ADDRESS . . : 3610 KIPLING RD
 CONTRACTOR : STE GENERAL CONTRACTORS, LLC
 OWNER . . . : MORGAN MARVIN & AMBER
 PARCEL . . . : 05-0633- - -0032- -05-
 APPL NUMBER: 17-50042688 CP NEW RESIDENTIAL (SFD)
 DIRECTIONS : T/S: 11/02/2017 08:46 AM LLUCAS ----
 401 N TO L ON CHRISTIAN LIGHT RD - PASS
 BOB & NANS STORE - TAKE RIGHT ONTO
 KIPLING RD - LOT 4 IS ON THE LEFT

FIELD REPORT

Date: 1/12/18
Project: 3610 Kipling RD
Location: Farmway-Varina, NC
Company: _____
Care of: Shane McLeod

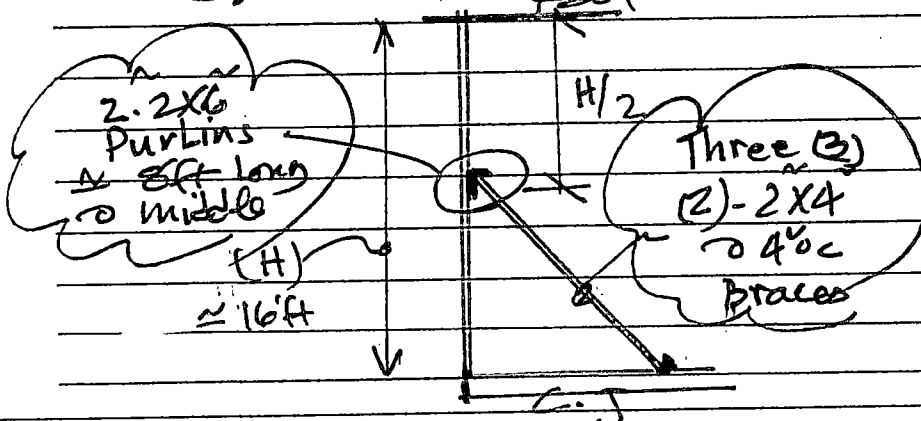
AS REQUESTED A-TAKLA VISITED THE PROPERTY and observed THE entire framing of THE House and FOUND adequate, per Plans and meets NCSRC - 2012 Edition.

NOTE Install Braces at Left side Gable end wall. (2) - 2x6 Purlins with (2) 2x4 Braces @ 40" o.c
